Clarification No. 1

TEAM HOUSE ADDITION

Rowan University
Glassboro, New Jersey 08028

CSCA Project Number: 101277
Rowan University Project Number: 70692

Sheet Number **SP-2**

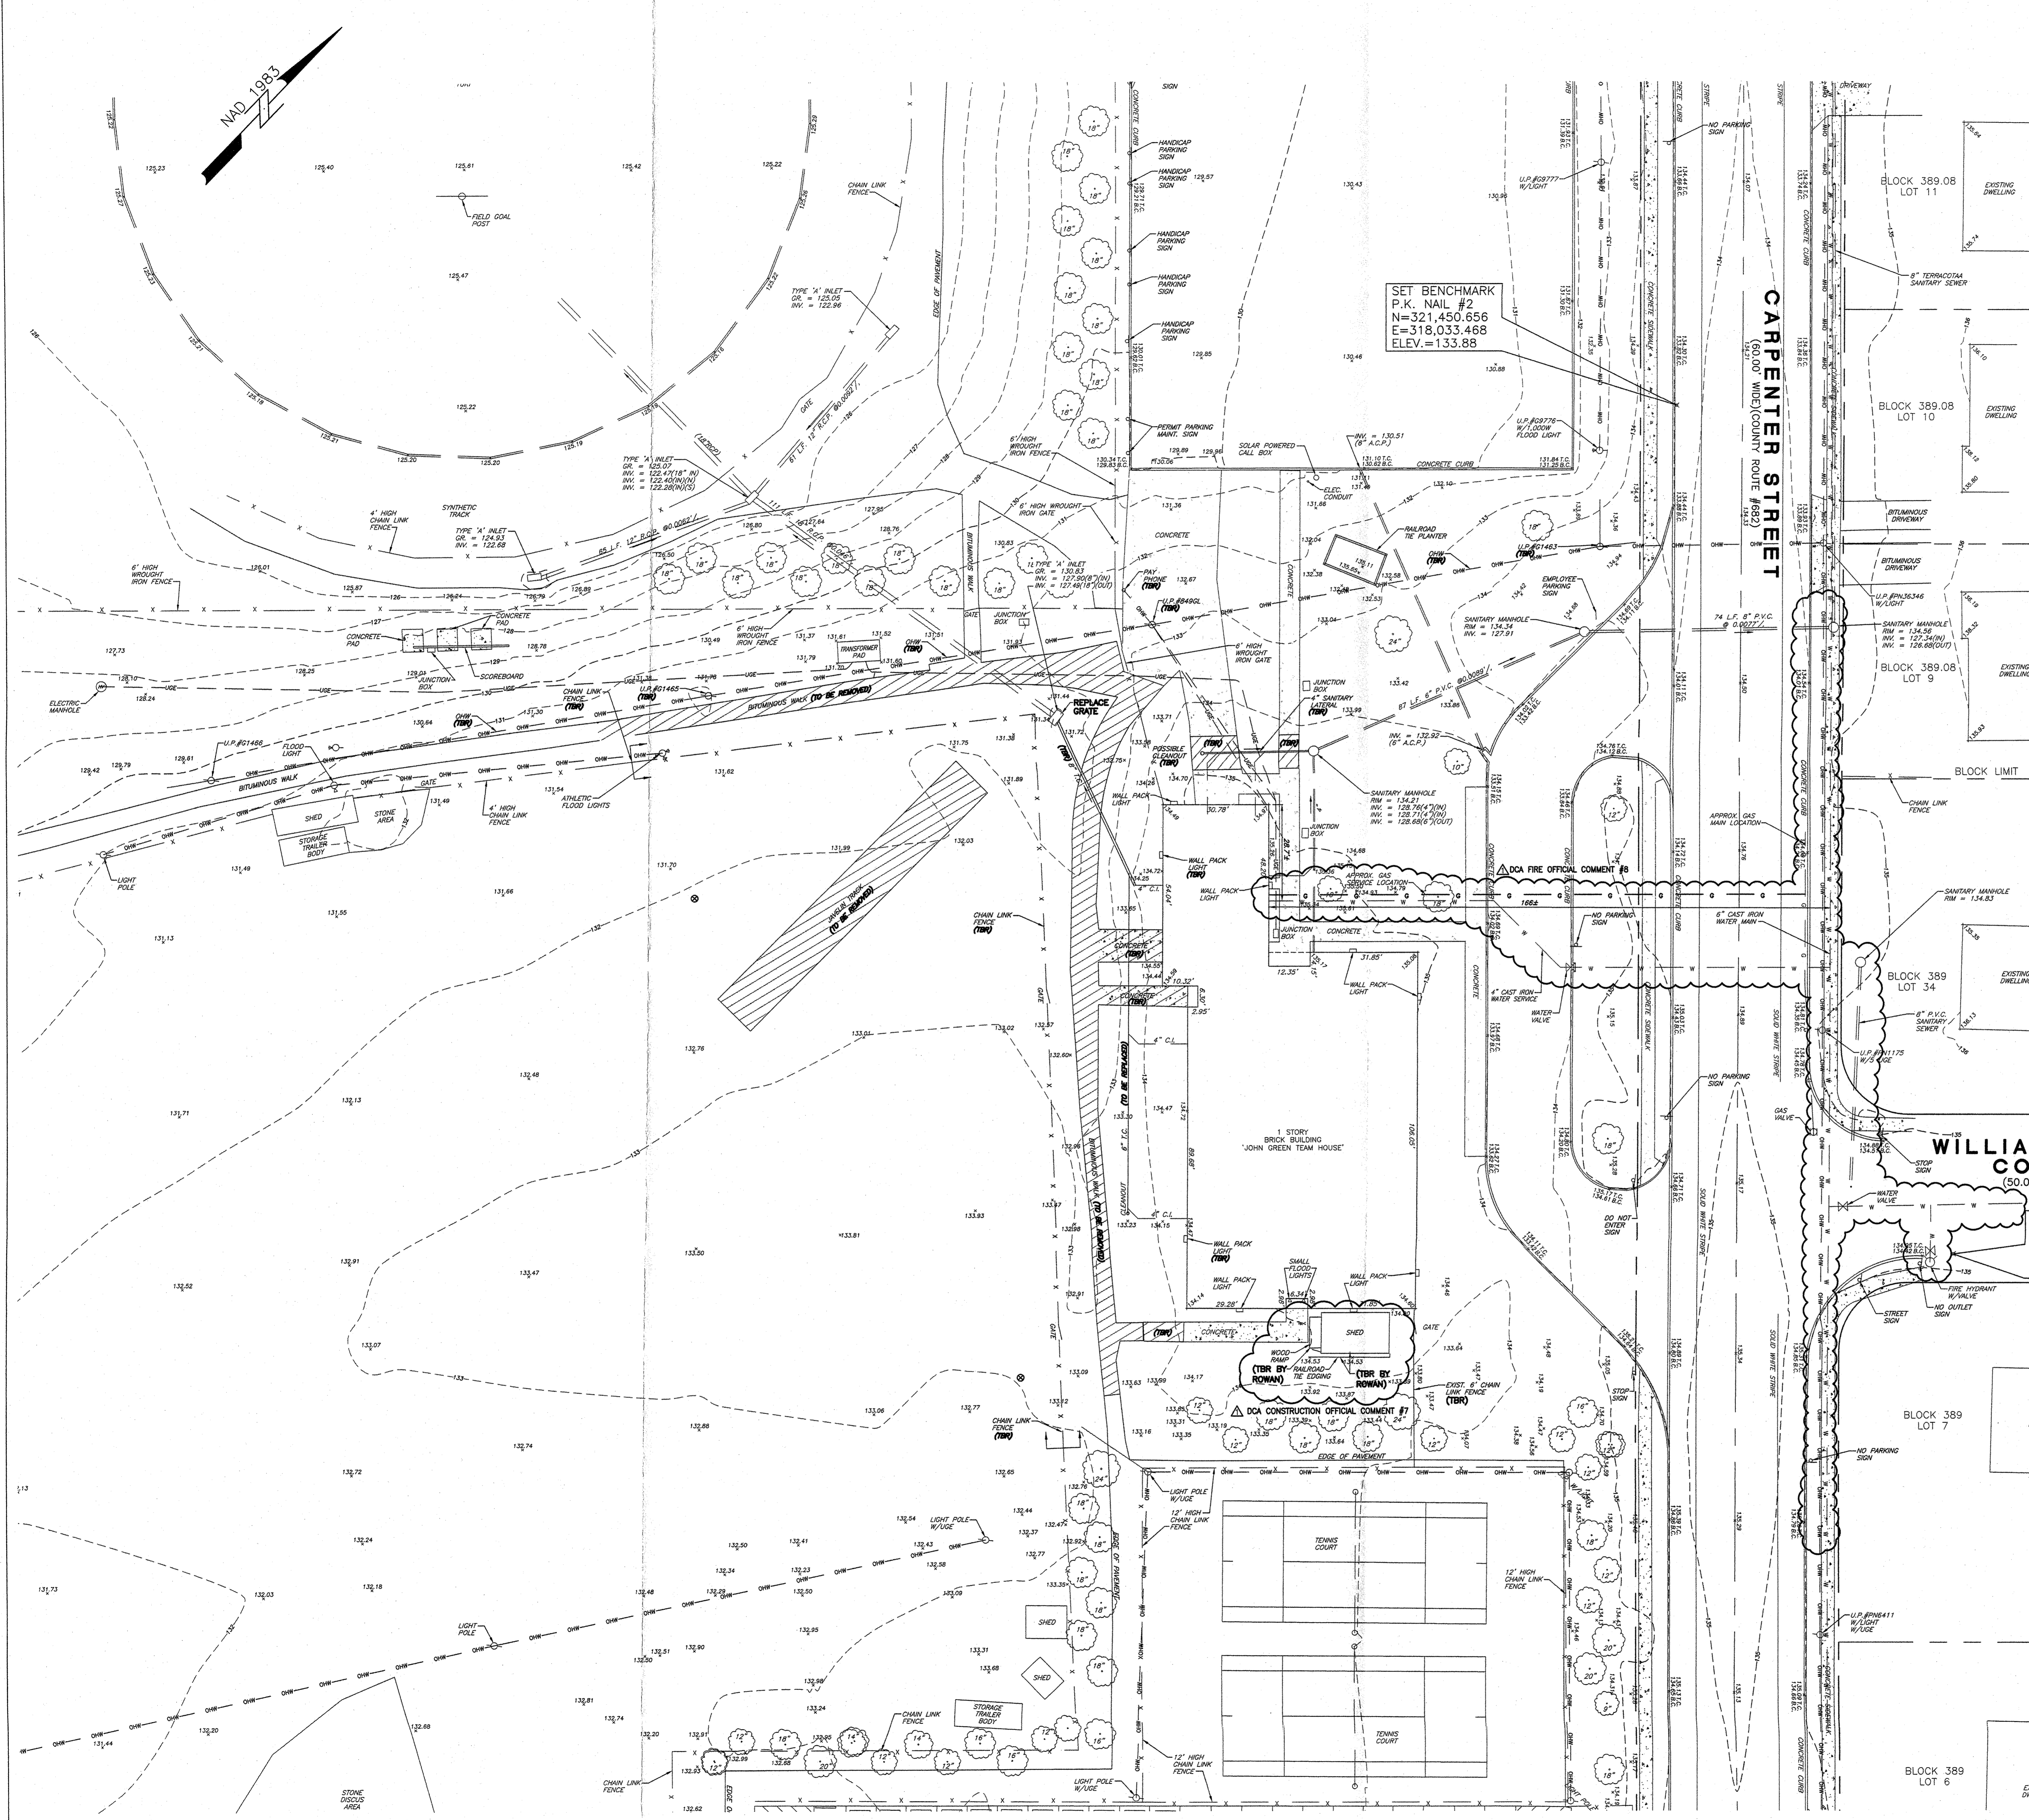
- Q. The addendum issued two pages of drawing no. ID1.0. Is that what was intended, or was some other drawing to be included?
- A. There should only be one ID1.0 drawing. Disregard the second ID1.0 sheet. The intended drawing was SP-2 attached.**

1. ADDED Drawing SP-2 – missing from Addendum #1
